## **MARY L. HODGES SUBDIVISION**

APPLICATION NUMBER 7 DATE January 19, 2006  
APPLICANT Mary L. Hodges Subdivision  
REQUEST Subdivision

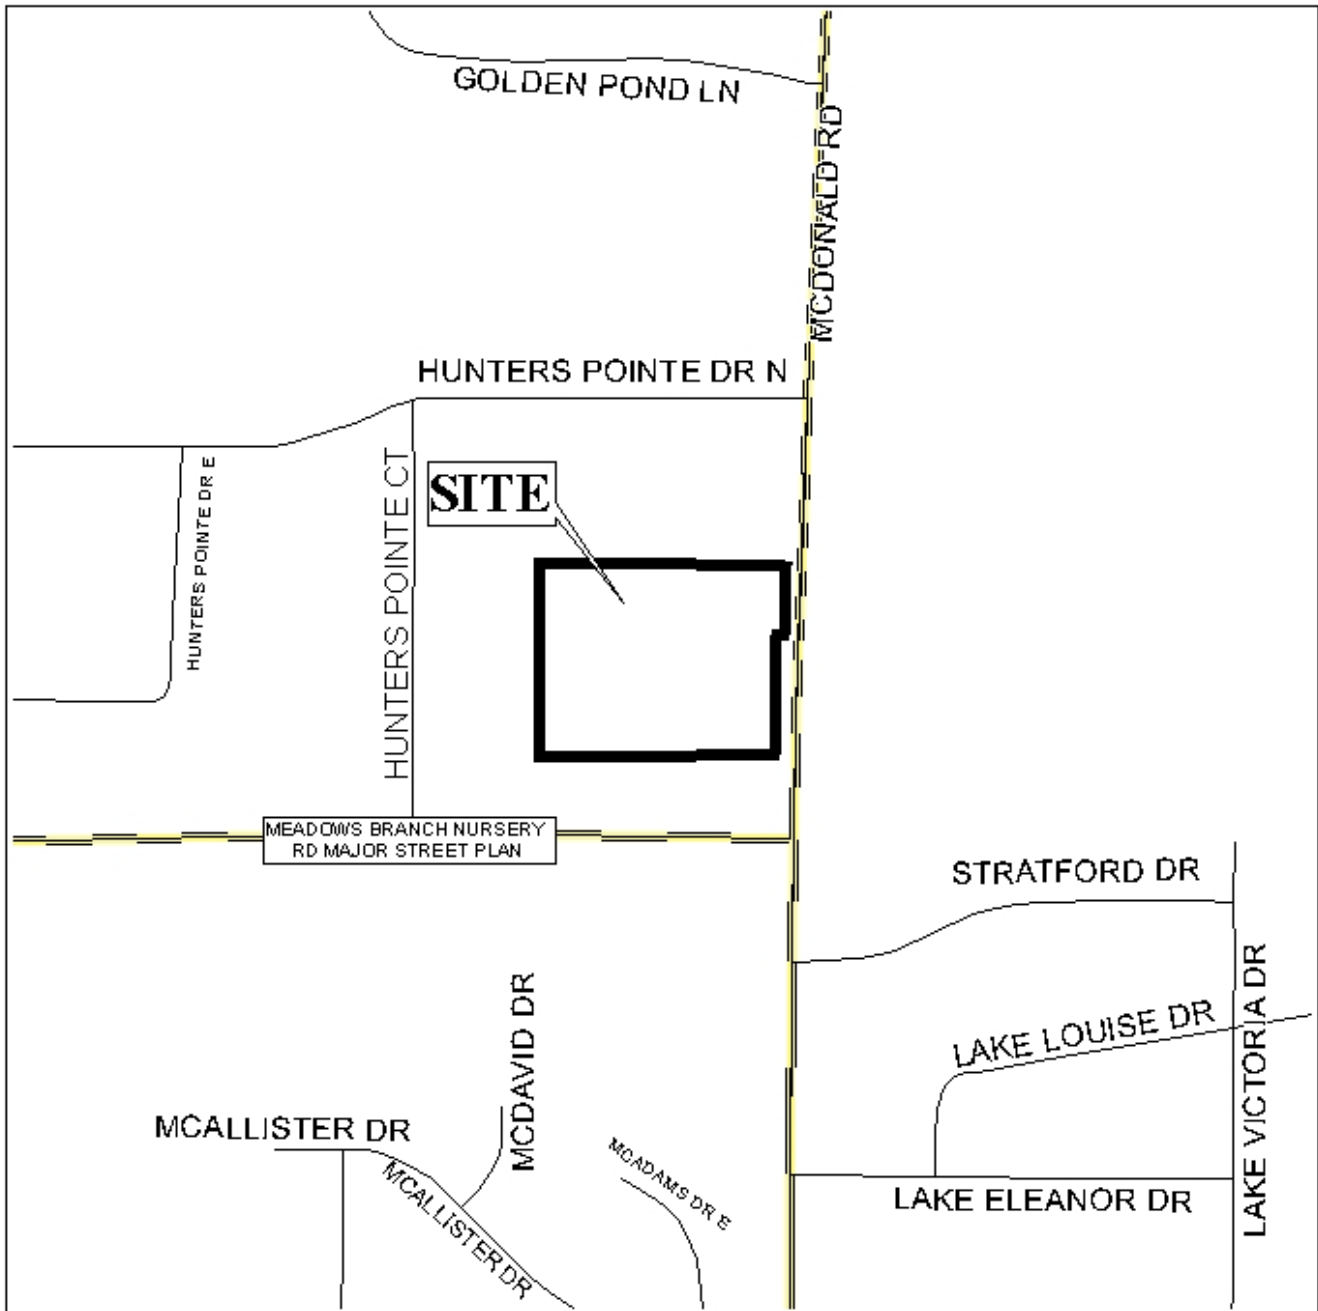
The site fronts McDonald Road, which has a right-of-way of 60 feet. McDonald Road is depicted on the Major Street Plan with a right-of-way of 100 feet; as such, dedication of sufficient right-of-way to provide 50 feet from the centerline will be required, as is illustrated on the final plat.

The purpose of the application is to create a two-lot subdivision from a metes and bounds parcel and a lot of record. A portion of the site was previously recorded as lot 37 of Hunters Pointe Unit One subdivision, and has already dedicated a portion of the required right-of-way; this should be reflected in the final plat.

There also appears to be a natural drain on the site, so approval from all applicable federal, state, and local agencies must be obtained prior to the issuance of any permits. As a means of access management, the site should be limited to a single curb cut per lot.

The plat meets the minimum requirements of the Subdivision Regulations and is recommended for Tentative Approval, subject to the following conditions: 1) dedication of sufficient right-of-way to provide 50 feet from the centerline of McDonald Road; 2) revision of the final plat to reflect the earlier dedication of right-of-way for a portion of the site; 3) receipt of approval from all applicable federal, state, and local agencies prior to the issuance of any permits; 4) the placement of a note on the final plat stating that the site is limited to a single curb cut per lot; and 5) the placement of a note on the final plat stating that any lots that are developed commercially and adjoin residentially developed property must provide a buffer, in compliance with Section V.A.7 of the Subdivision Regulations.
